SITE INSTRUCTION

SI #24

PROJECT : Forestside
PROJECT # : 1331.15
DATE : Oct.12, 2022

Title: Revisions to plans as itemized.

1:50 A-301d1

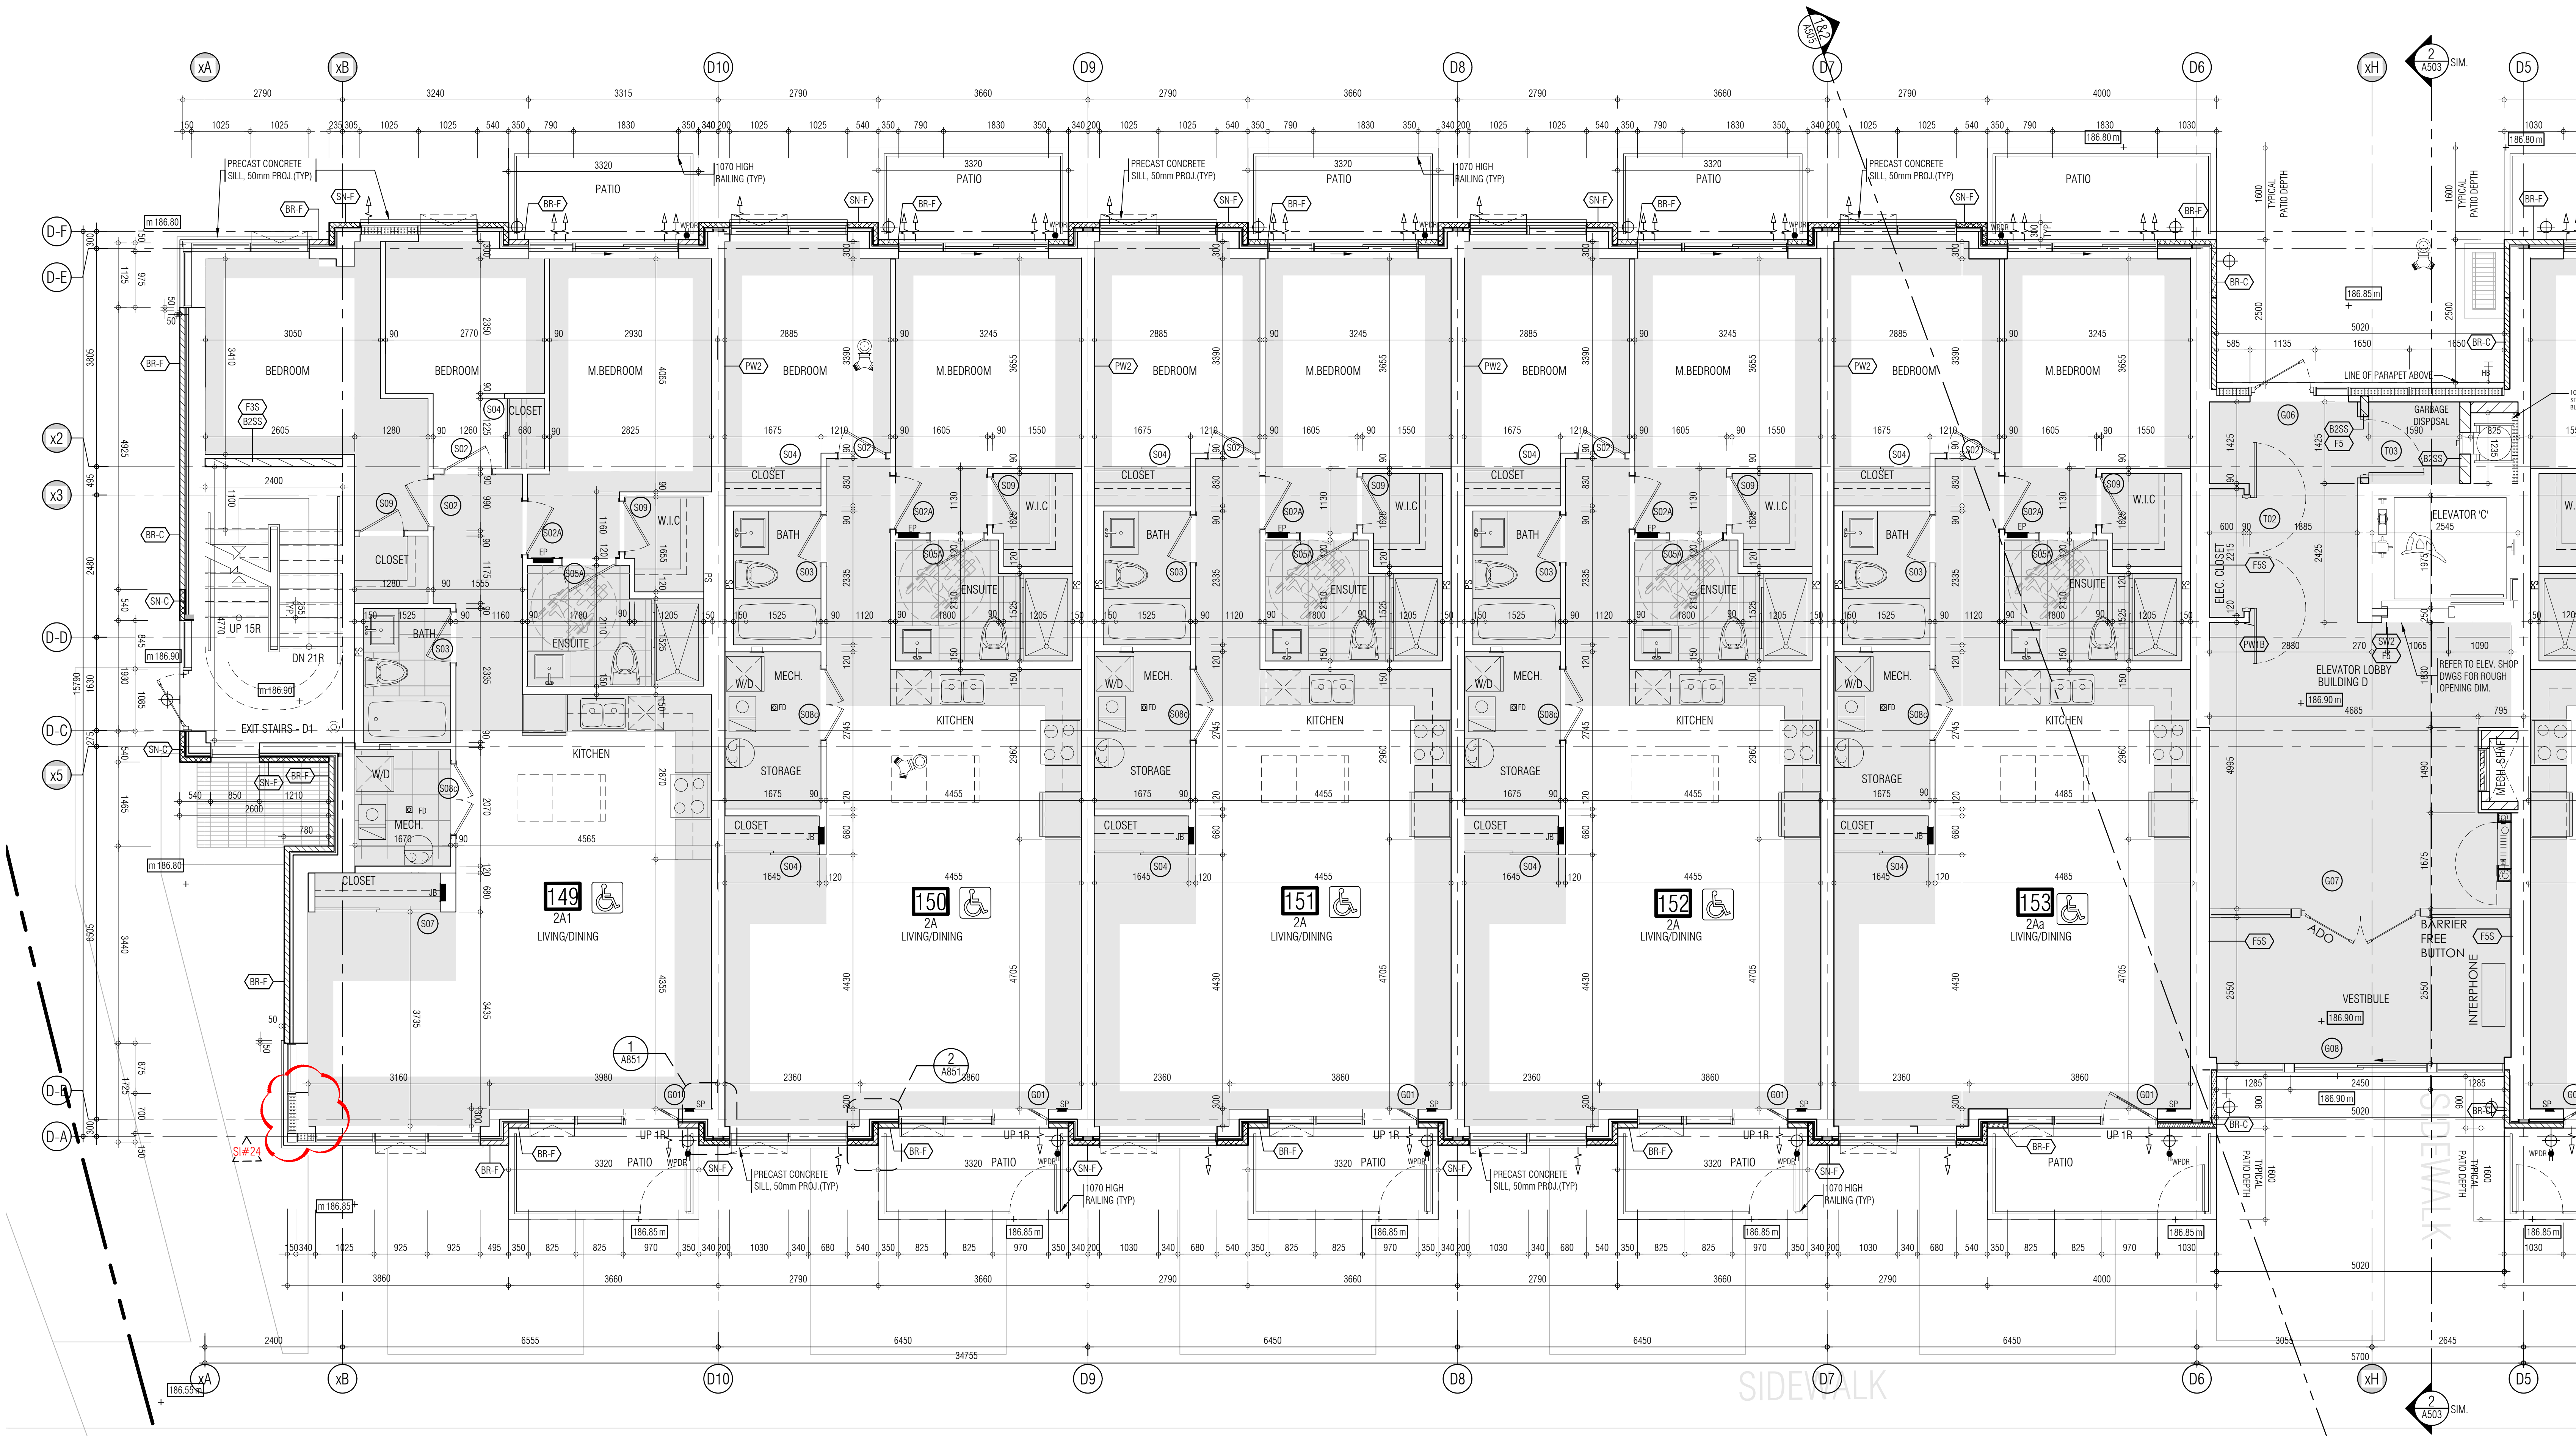
Reference:	Changes:
A301d1, A301d2	Ground Floor Plan	Updated column size from 500mm to 650mm on building 'D' ground floor only.
A304d1, A304d2	4 th Floor Plan	Move window to Line up with window from 3rd floor.
A404, A404d3	Building 'D' Elevations	Update window widths and line up window from 3rd floor.
CS301-OS, CS301a1	1 st Floor Plan	Updated column size from 500mm to 650mm on building 'D' ground floor only.
